Minutes of the North Carolina Building Code Council
July 14, 2020
Raleigh, NC

Part B – New Petition for Rulemaking

FIGURE R4603.6(d)
CORNER PILE CONNECTION

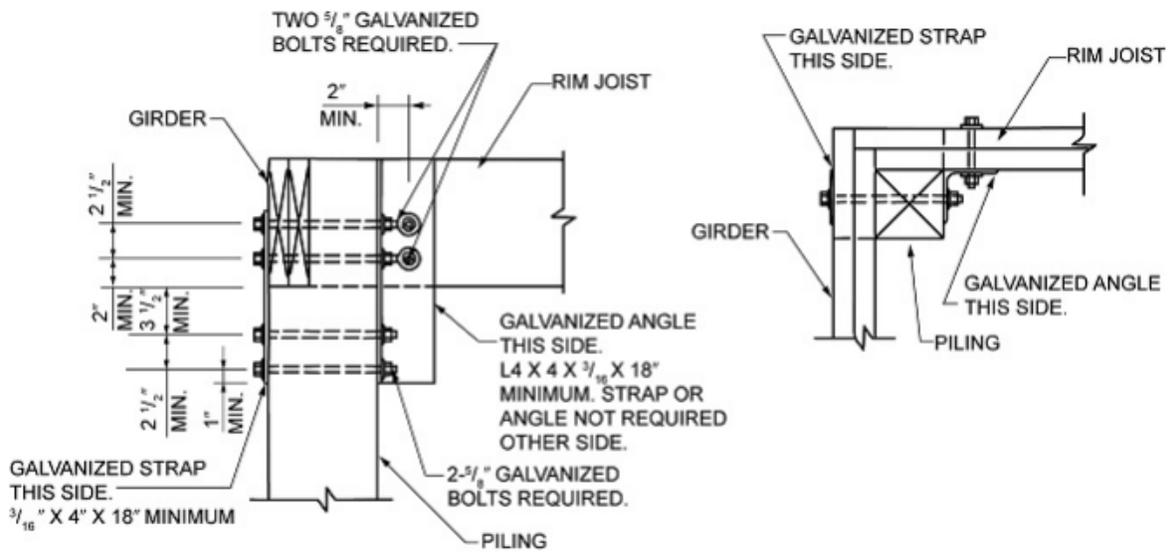
R4603.6.1 Tying at corners. At corners, girders shall be connected to the pile with a minimum 3/16 × 4 × 18-inch (5 × 102 × 467 mm) hot dip galvanized strap bolted with two 5/8 inch (15.9 mm) galvanized through bolts on the exterior and a minimum L4 x 3/16 x 1'-6" (102 × 5 × 467 mm) galvanized steel angle bolted with two 5/8 inch (15.9 mm) galvanized through bolts on the interior in accordance with Figure R4603.6(d1), or with a minimum of (2) 3/16" x 4" x 18" (5x102x467 mm) hot dip galvanized straps installed on the outside of the girders with fasteners per table R4603.6.1 and in accordance with Figure R4603.6 (d2).

FIGURE R4603.6(e)
CORNER PILE CONNECTION

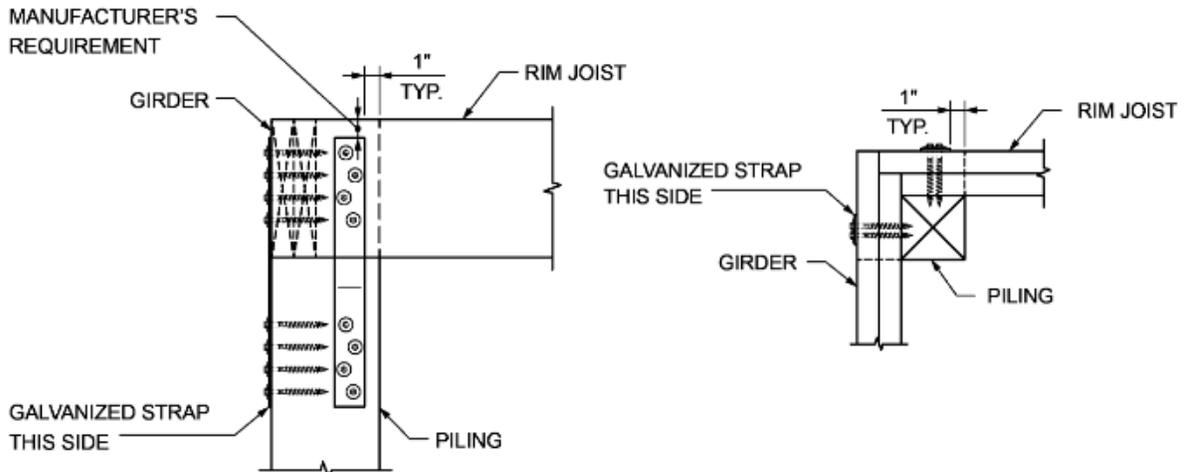
<u>Amount Piling is Notched</u>	<u>Associated Figure</u>	<u>Hardware</u>	<u>Fasteners</u>
<u>> 50%¹</u>	<u>R4603.6(d)</u>	<u>one 3/16"x4"x18"</u>	<u>six 5/8" bolts²</u>
		<u>one L4x3/16x18"</u>	
	<u>R4603.6 (e)</u>	<u>one 3/16"x4"x18"</u>	<u>eight 0.27"x4" each³</u>

Figure R4603.6(e)(f)

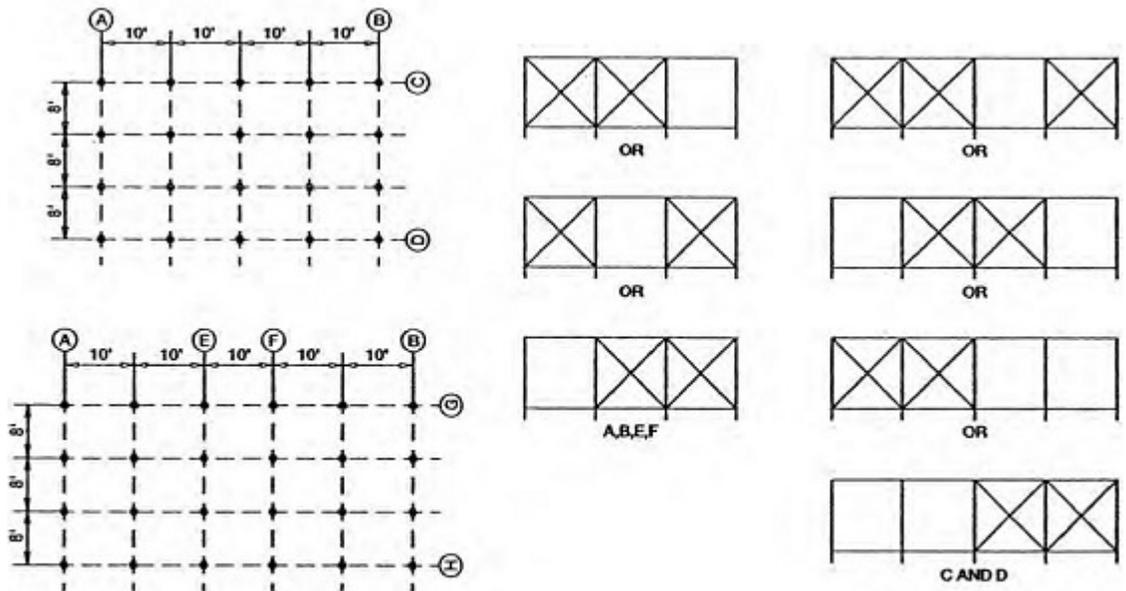
R4603.6.2 Bracing of Pilings. Bracing of pile foundations is required where the clear height from ground to sill, beam or girder exceeds 10 feet (3048 mm) or the dwelling is more than one story above piles. A line of X-bracing is defined as a row of piles with X-bracing provided in at least two bays. A line of X-bracing shall be provided at all exterior pile lines. Where the perimeter lines of X-bracing exceed 40 feet (12 192 mm), an additional line of X-bracing shall be provided near the center of the building. See Figure R4603.6(e)(f). X-bracing shall be with 2 × 10s through bolted with two 3/4-inch (19.1 mm) bolts at each end. The code official is permitted to accept alternate bracing designs if they bear the seal of a registered design professional.

**FIGURE AM105.2
TYPICAL DECK GIRDER SPANS**

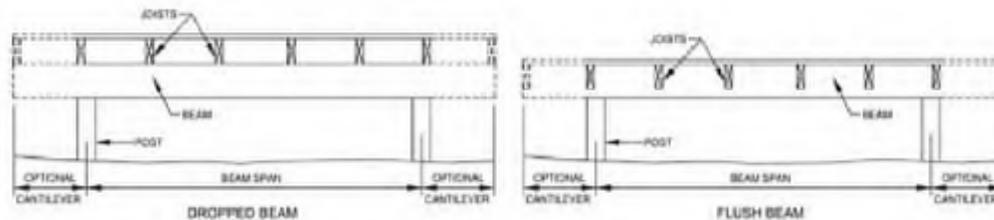
AM105.2 Girder span for uncovered porches and decks. ~~Maximum allowable spans for wood deck girders, as shown in Figure AM105.2, shall be in accordance with Table AM105.2. Girder plies shall be fastened with two rows of 10d (3-inch x 0.128-inch) nails minimum at 16 inches (406 mm) on center along each edge. Girders shall be permitted to cantilever at each end up to one-fourth of the actual beam span. Splices of multispan beams shall be located at interior post locations.~~

FIGURE AM106.1
TYPICAL DECK JOIST SPANS

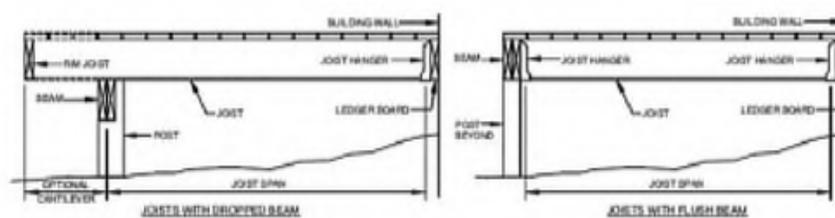
~~AM106.1 Joist spans for uncovered porches and decks~~ and cantilevers. Joists spans shall be based upon Table R502.3.1(2) with 40lbs per sq ft of live load and 10 lbs per sq ft of dead load. Floor joists for exterior decks may be cantilevered per Table R502.3.3(1). Maximum allowable spans for wood deck joists, as shown in Figure AM106.1, shall be in accordance with Table AM106.1. Deck joists shall be permitted to cantilever not greater than one fourth of the actual, adjacent joist span.
